**PIC16F627A/628A/648A Rev. A Silicon/Data Sheet Errata**

The PIC16F627A/628A/648A parts you have received conform functionally to the Device Data Sheet (DS40044A), except for the anomalies described below.

## Clarifications/Corrections to the Data Sheet:

## 3. Module: Pin Diagrams

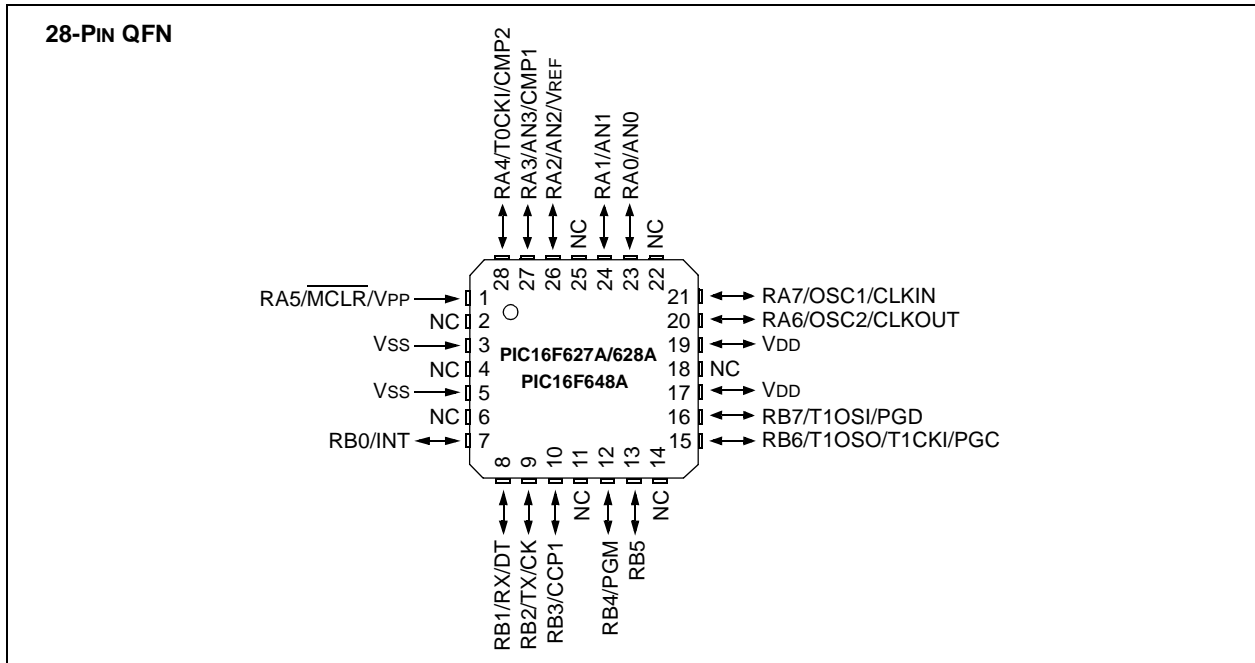
On page 2, Pin Diagrams, Pin 1 of 28-pin QFN package should be labeled: RA5/MCLR/VPP.

**FIGURE 5-4: BLOCK DIAGRAM OF THE RA4/TOCKI PIN**

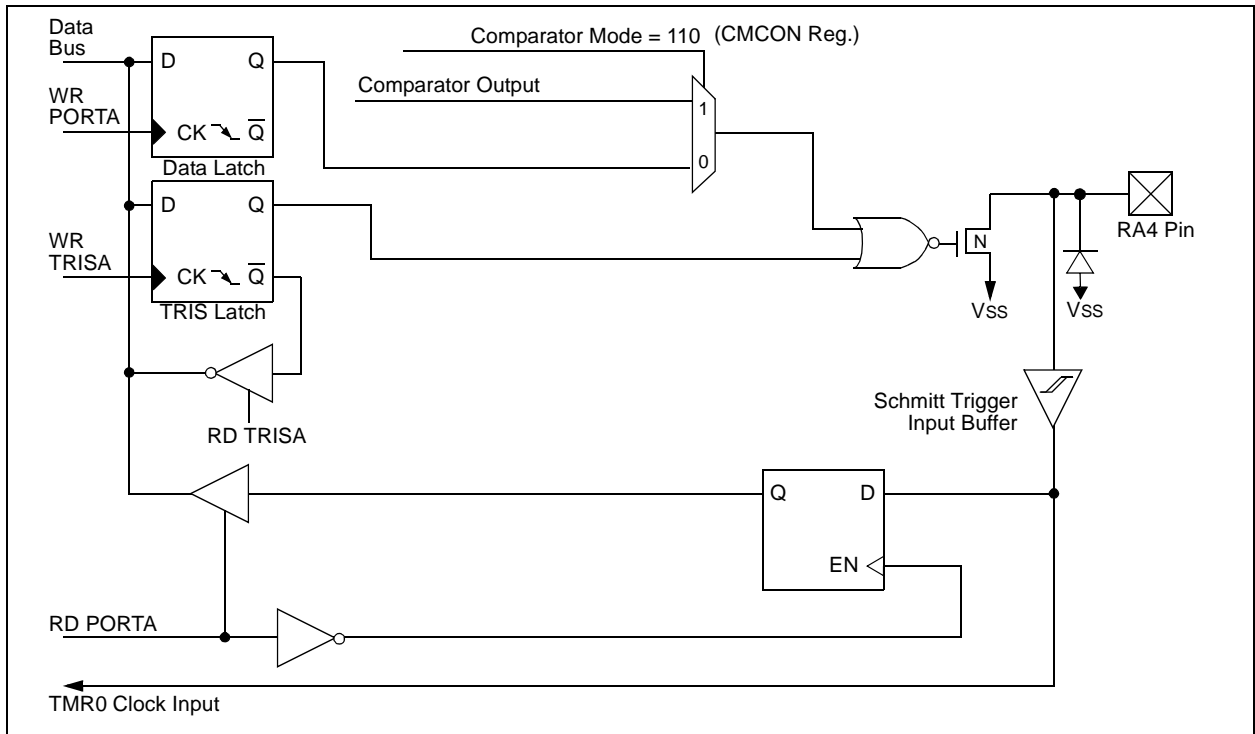
In Figure 5-4, the diode between VDD and the RA4 pin should be deleted.
